ADDENDUM NO. 1

October 9, 2014

**Westford Museum
Historic Rehabilitation**

ASK-1

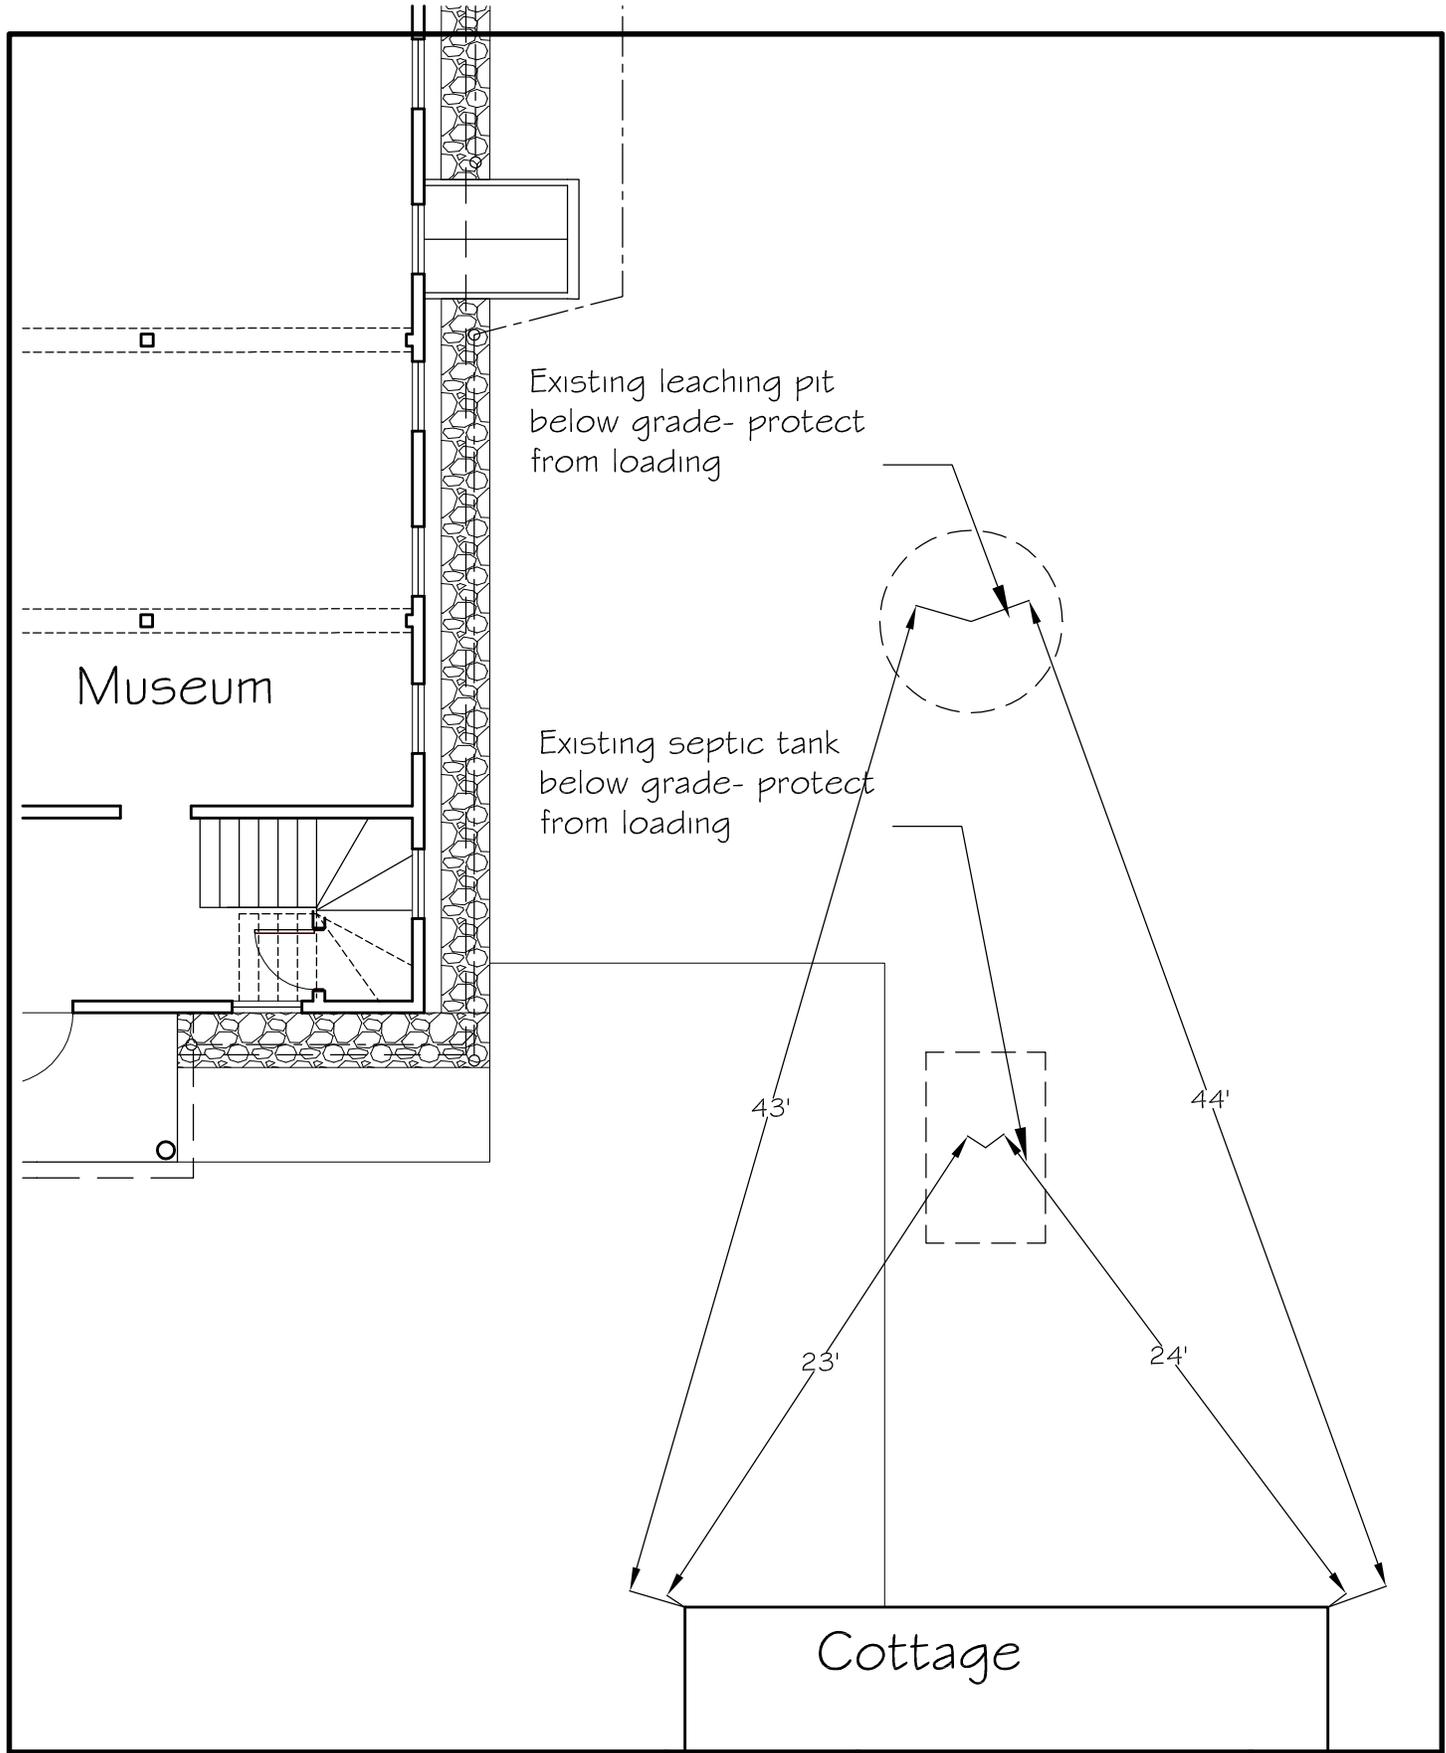
A-101: Approximate septic tank and field locations are added for information. See ASK-1.
